ADDRESS: 1631 ARCH ST

Proposal: Remove cornice rosettes

Review Requested: Final Approval

**RE: Verizon – 1631 Arch Street Façade Repairs – Terra Cotta
Philadelphia, PA 19103
File No. 3168.0007.00**

Photograph 7 – Overview of removed/fallen terra cotta flower unit.

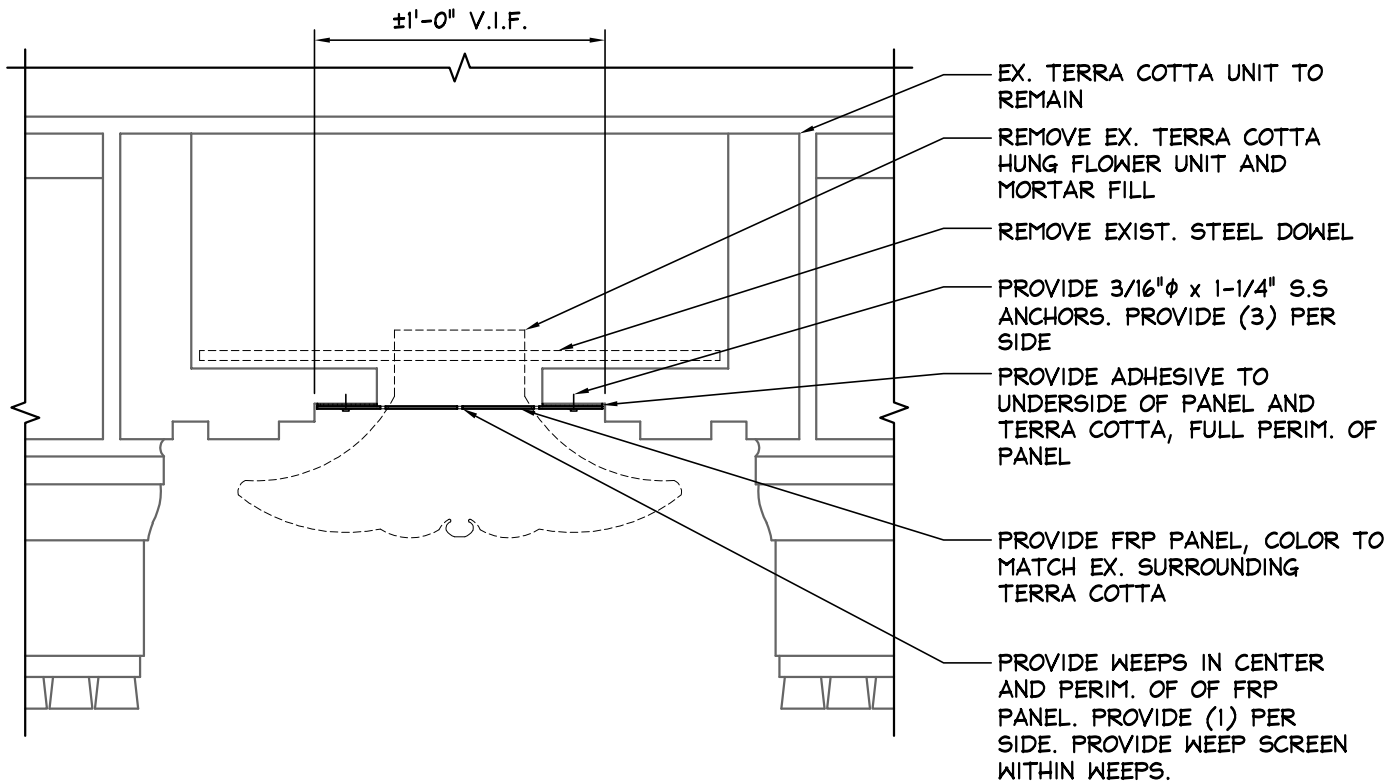
During the ongoing façade repairs O'Donnell & Naccarato (O&N) performed a review of the existing hung terra cotta flower units at the underside of the cornice at the sixteenth floor (See Photographs 4-6). During the ongoing façade repairs at the west elevation a hung terra cotta flower unit became dislodged from the cornice and fell onto the scaffold below. Upon further investigation and sounding of the units, O&N identified two additional terra cotta flower units at the west elevation that appeared to be dislodged. During the attempt to re-secure one of the dislodged units it became loose and required removal (See Photograph 7).
